Service Bulletin

PRELIMINARY INFORMATION

Subject: Pop Noise From Fuel Tank After a Cold Start or EVAP Purge Event

Models: 2010 -2015 Chevrolet Equinox
2010-2015 GMC Terrain

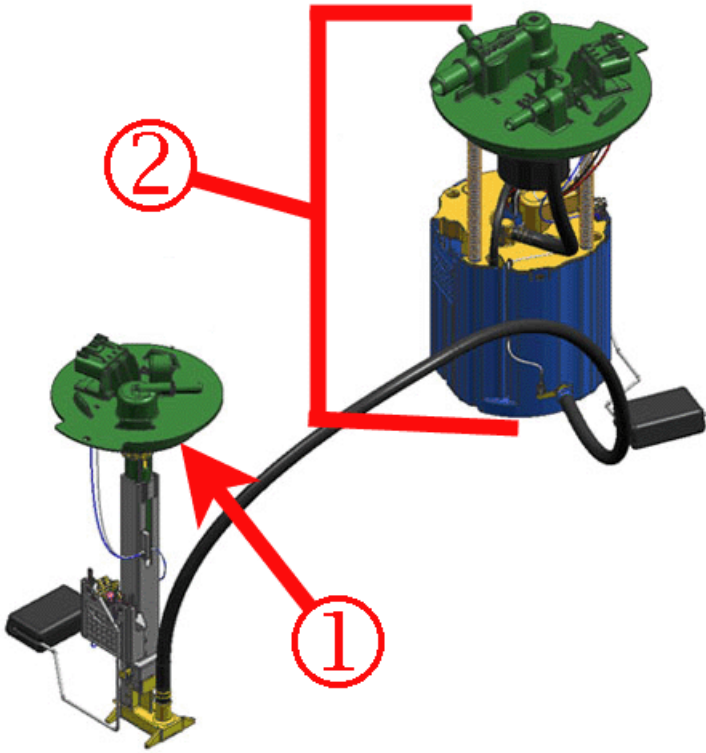
The technician should be able to duplicate the concern by commanding a purge and seal on the EVAP system using GDS2.

As the vacuum reaches 3 to 5 inches, the pop/popping noise should be duplicated. The cause for this concern is the auxiliary fuel module in the left side of the fuel tank changing height (spring loaded leg).

After ordering the auxiliary fuel module, remove it from the box and verify the letters "PPA" are cast into the top of the fuel module flange.

This is the revised auxiliary fuel module designed to correct the pop/popping noise. The original auxiliary fuel module has "POM" cast into the flange.

Important: The condition described in this PI applies only to the auxiliary fuel pump module assembly. The Parts Catalog calls this auxiliary pump component the "sender kit" which is the correct part for this repair. Replacing the primary fuel pump module assembly would NOT correct this noise condition. The parts catalog calls this primary pump component the "module kit" which is the incorrect part for this repair.

1. Flange location of the auxiliary fuel module (sender kit)
2. Primary Pump NOT the correct component to replace (module kit)
